MECKLENBURG COUNTY
DEPARTMENT OF ENVIRONMENTAL HEALTH

APPLICATION FOR SOIL INVESTIGATION

SIR. NO. 20253
T.C. NO. PO 053-092-19
DATE: November 30, 1983

SITE EVALUATION

**See Diagram on Back (includes: soil areas, property lines, roads, streams, gullies, wet areas, fill areas, wells, water bodies, slopes)

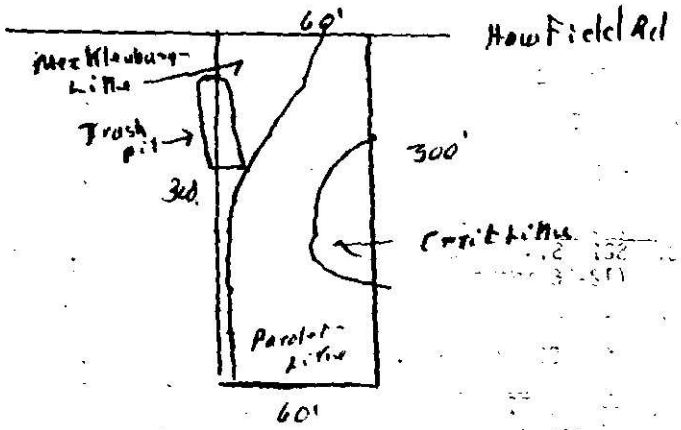
Recommendations/Comments: Part of old trash pit appears to be on lot
